RE: Comments of Renewable Northwest, Docket UE-200301

Utilities and Transportation Commission's January 5, 2021, Notice of Opportunity to File Written Comments Relating to Avista's 2021 Draft Integrated Resource Plan for Electricity, Docket UE-200301.

Figure 1. Li-ion battery storage projection (in \$/kW) from NREL’s Annual Technology Baseline 2020.⁹

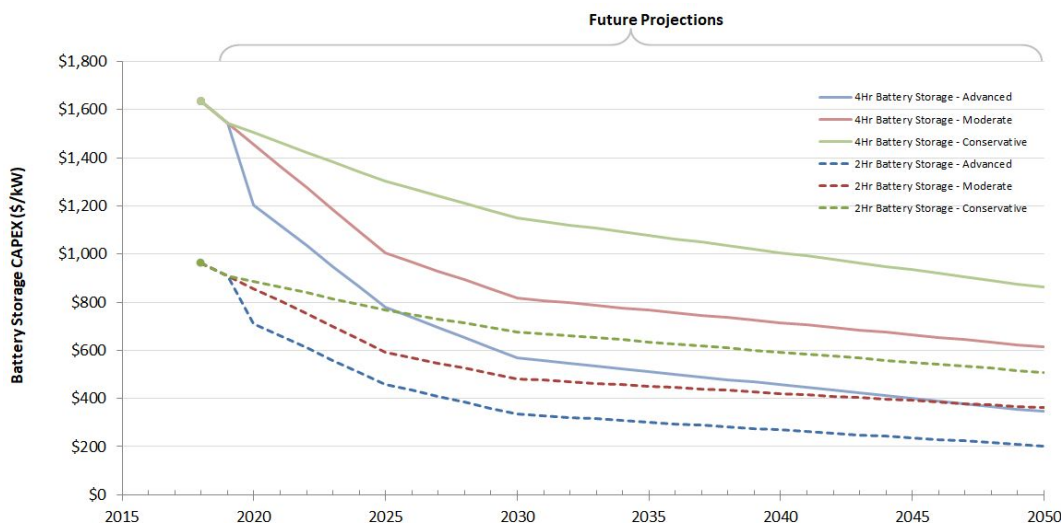
Considering Avista’s assumptions for lithium-ion battery storage, we recommend the Company review the data informing the levelized cost (\$/kW) for the preferred 4-hour lithium-ion battery, as there appears to be a gradual price increase after 2033 rather than a steady decline, which would be expected.⁸ For example, the National Renewable Energy Laboratory’s (“NREL”) 2020 Annual Technology Baseline (“ATB”) reports a trend of cost reductions (illustrated as \$/kW in *Figure 1*) through to 2050.
